Corrections to

**Information technology—
Telecommunications and information exchange between systems—
Local and metropolitan area networks—Specific requirements—**

Part 3: Carrier sense multiple access with collision detection (CSMA/CD) access method and physical layer specifications

Correction Sheet

**Figure 2-2—Service specification primitive relationships
(optional MAC control sublayer implemented)**

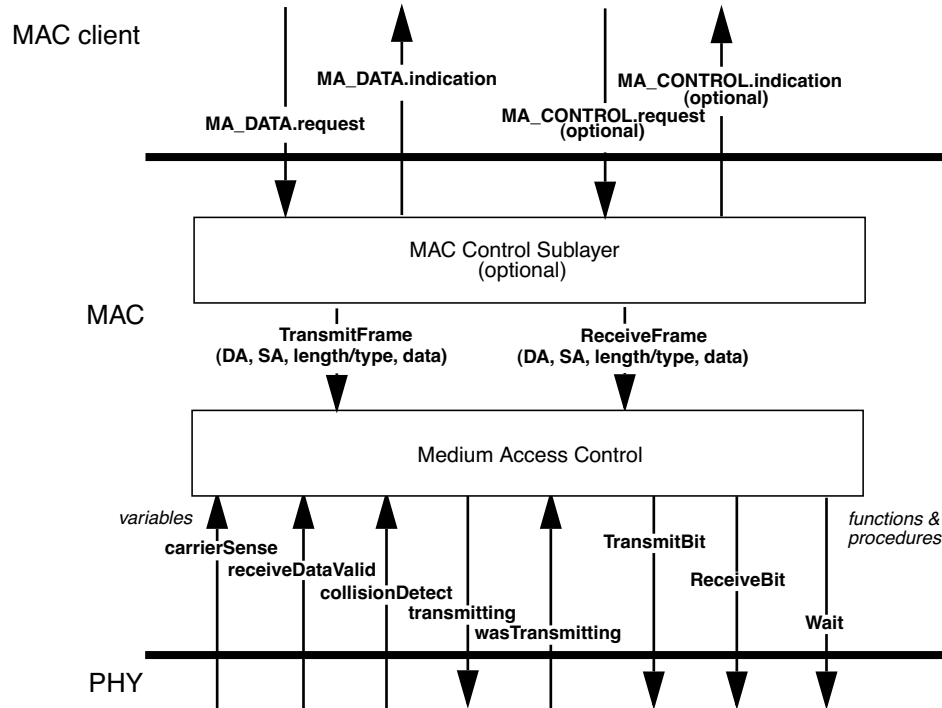
Page 34: Figure 2-2.

Replace Figure 2-2 with the following figure.

NOTE—The deletion of the wasTransmitting arrow, restored by the above, has been proposed by an IEEE P802.3 Revision Request, (URL - http://www.ieee802.org/3/maint/requests/maint_1021.pdf) which is currently being balloted as part of IEEE P802.3ag Maintenance Ballot #6. This was published in IEEE Std 802.3, 2000 Edition in error.
